ADDENDUM NO. 5

Date: September 25, 2018
Project: **Secondary Treatment Plant Upgrade & Recycled Water Expansion**
Job No.: 12600-07/16650-02

The following changes and/or clarifications are hereby made to the Contract Documents, and shall become a part of the Contract Documents dated July 2018.

Public Parking & Contractor Parking Restriction Plan Contractor Employee Parking/Materials Storage Area

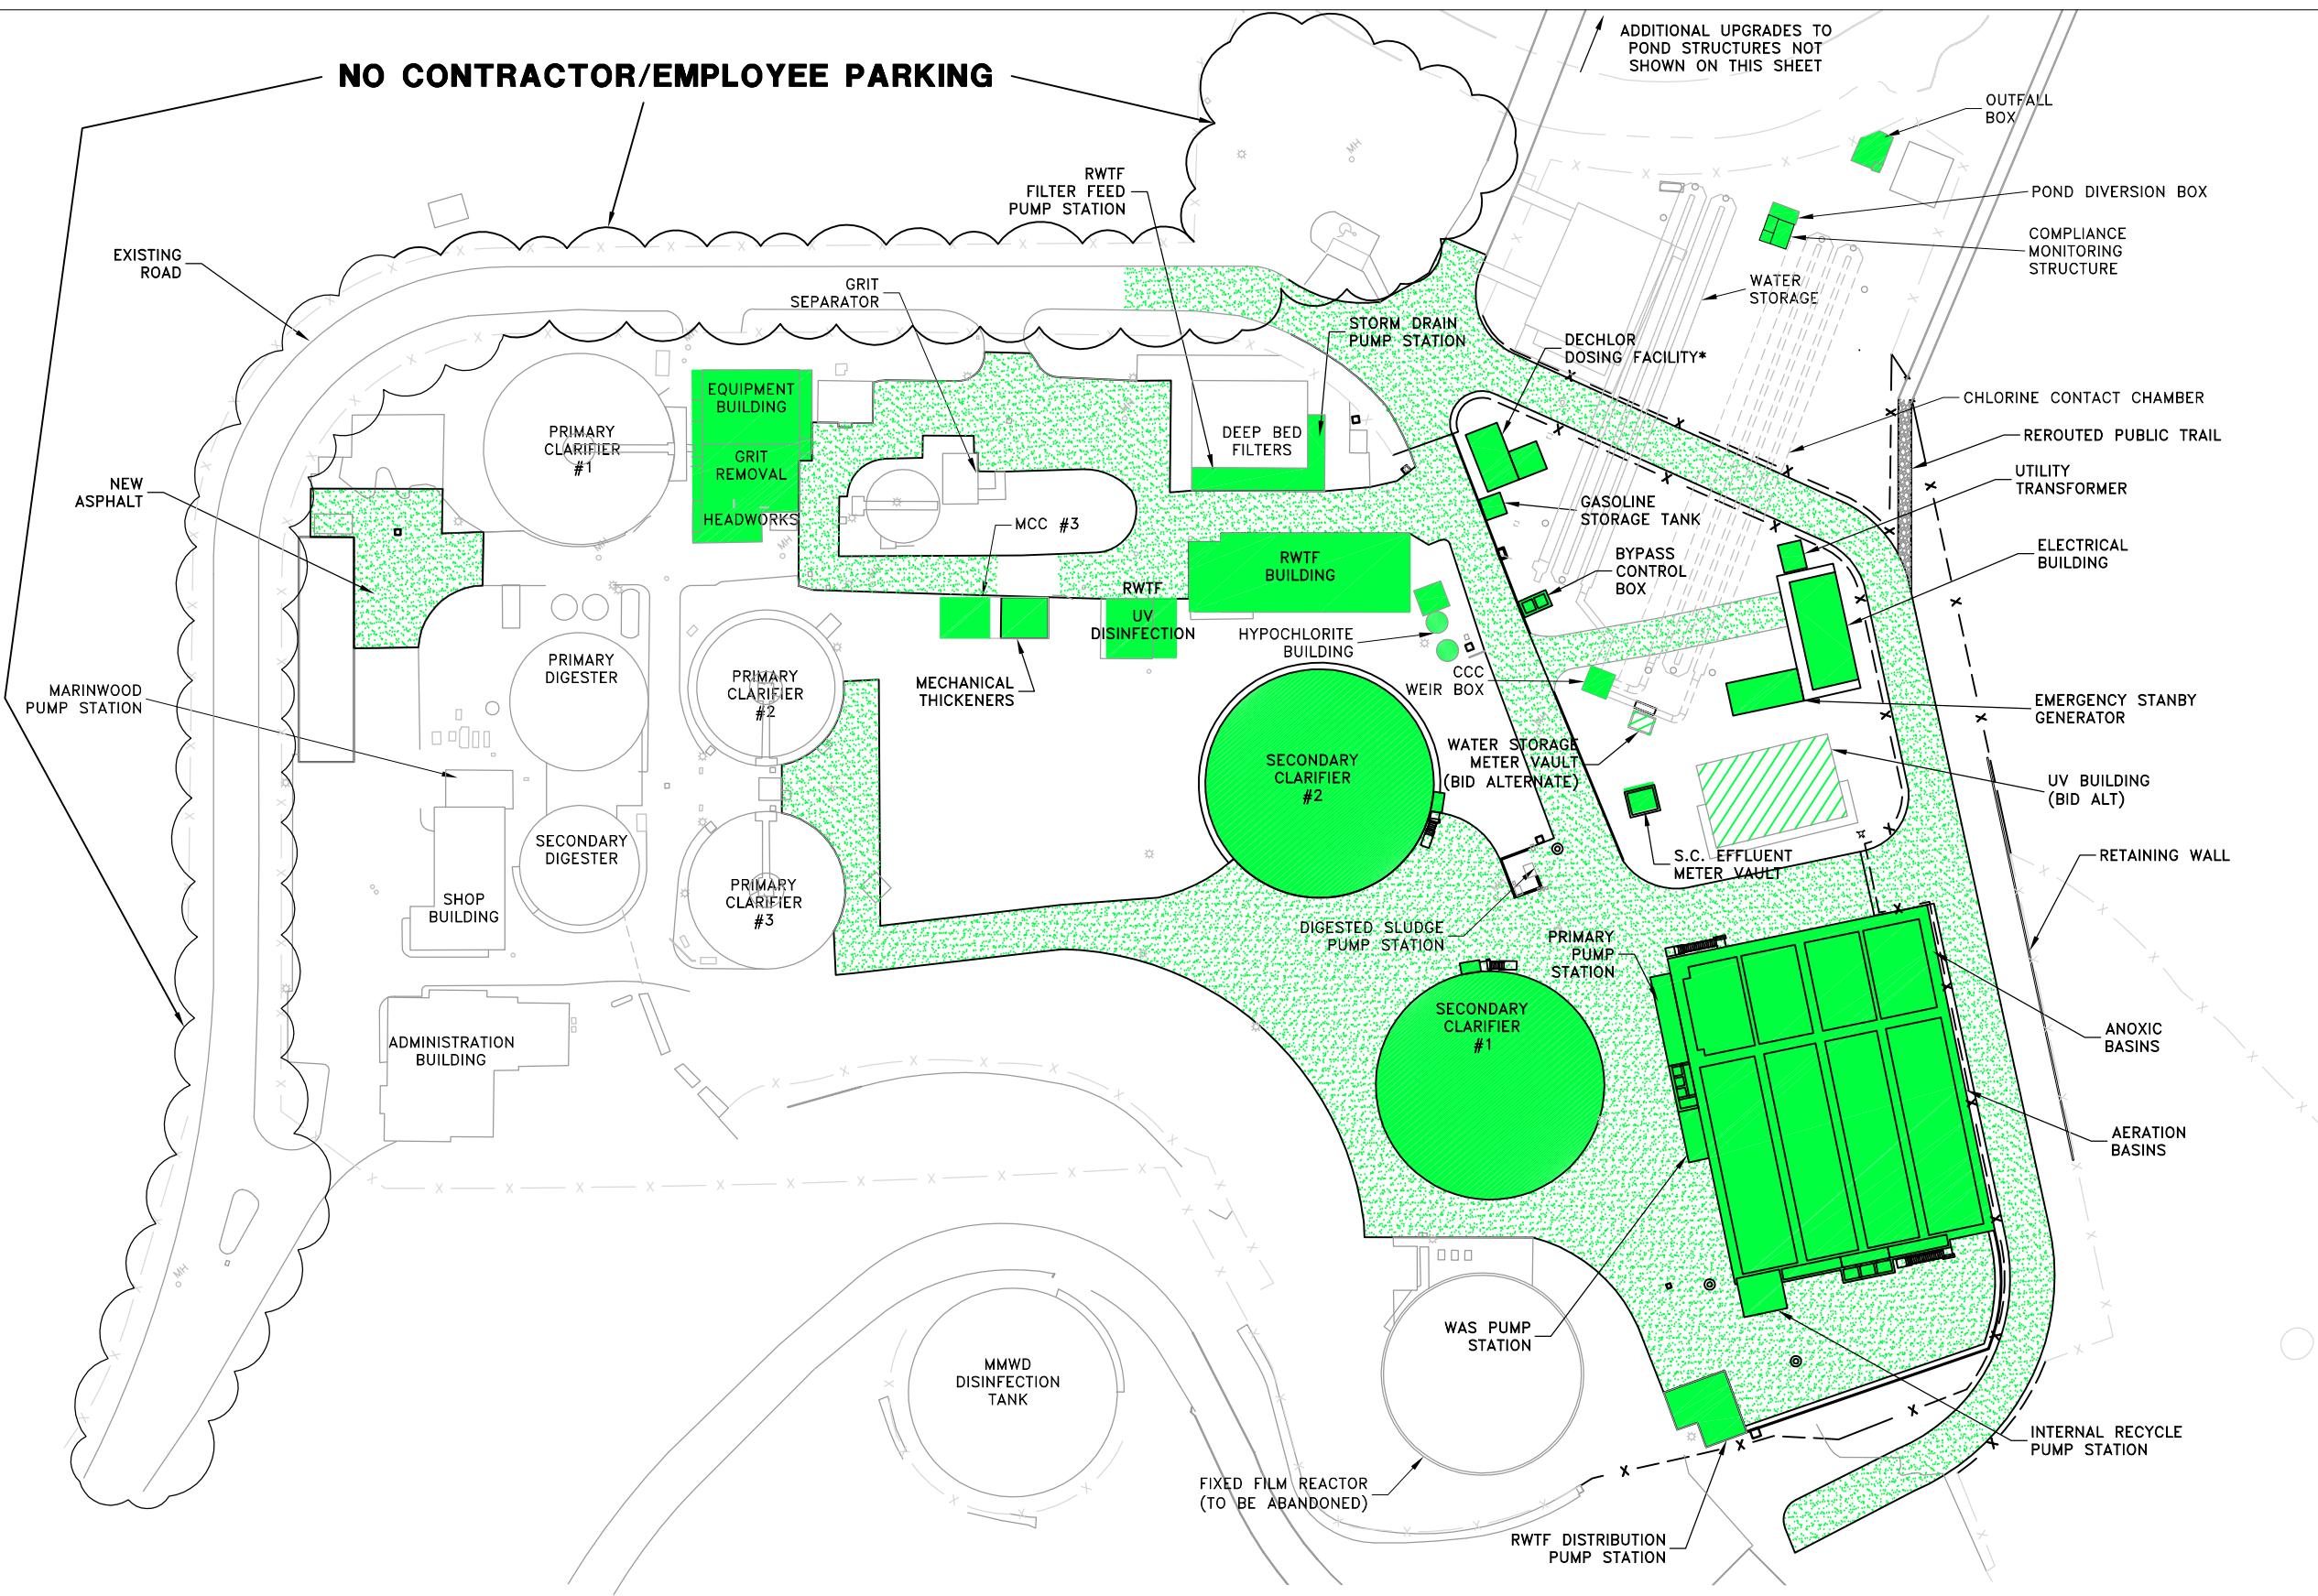
1. The bid opening date has been moved to **Thursday, October 4th at 2:00 PM** local time.
2. To reiterate, the Contractor will not be able to use the existing public road and parking area for staff parking or staging. To clarify, a site plan indicating the no-parking areas is **attached to this addendum for reference**.

4. The District has secured area (approximately 1.5 acres) for contractor employee parking and material storage/laydown at the San Rafael Airport (400 Smith Ranch Road, San Rafael, CA 94903), approximately one (1) mile from the jobsite, available beginning mid-December 2018. The contractor will be responsible for general housekeeping and sanitation, fencing (with entrance/exit gates) and security, and any minor grading necessary to utilize the parking and laydown area, and returning the area to the pre-existing condition upon exiting the site. No recreational vehicle parking/overnight parking will be permitted.
